PROJECT: SONA

2066-ABWA-XX-XX-FN-A-(01)-0021 – NMA response

Please see below the responses in support of points raised on 7th December 2023 by Manchester City Council regarding application 138498/NMC/2023.

Ventilation grille to brickwork

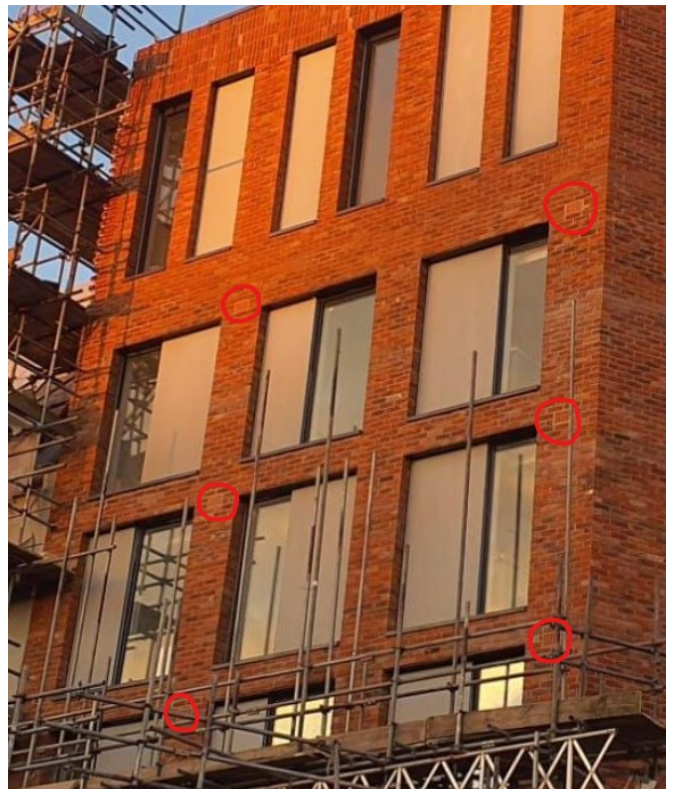
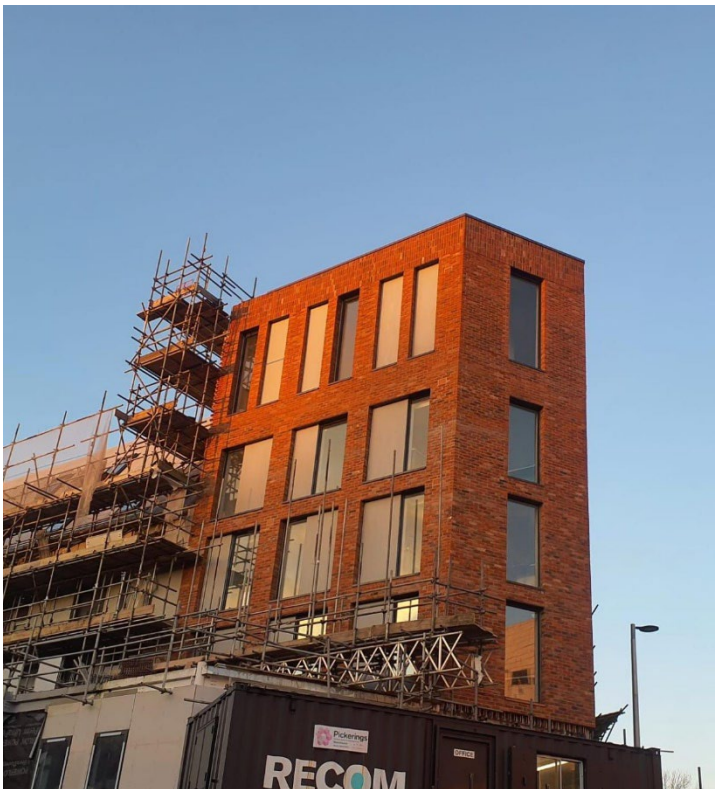
Please see below an image of the terracotta airbricks within the areas of brickwork:

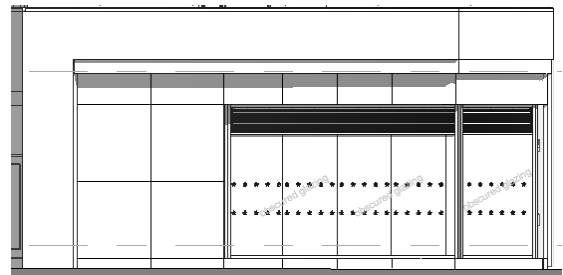
Following the concerns raised by planning on quantity, position, and scale we have reviewed the extents of the louvres and through the redesign of the mechanical services, have been able to reduce the louvres area by 50%. The louvres that do remain are predominantly on the Polygon Street elevation, with the exception of one louvre and one area of perforated alloy cladding (with the louvre secreted behind) on Brunswick Street.

Polygon Street elevation as submitted for application

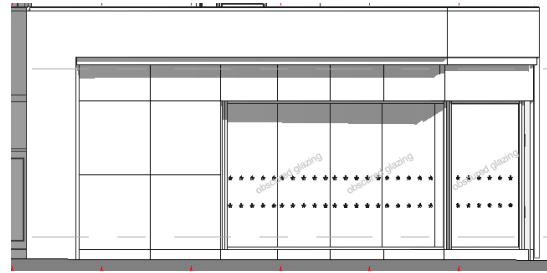
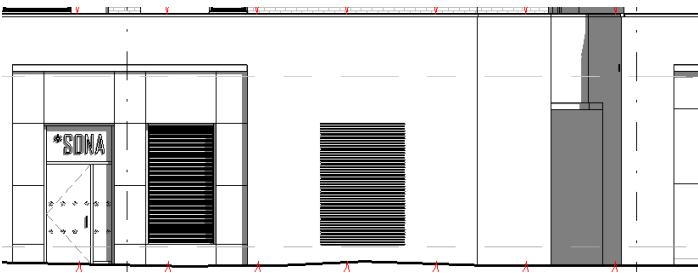
The comparison below illustrates the extent of the change:

Revised Polygon Street elevation
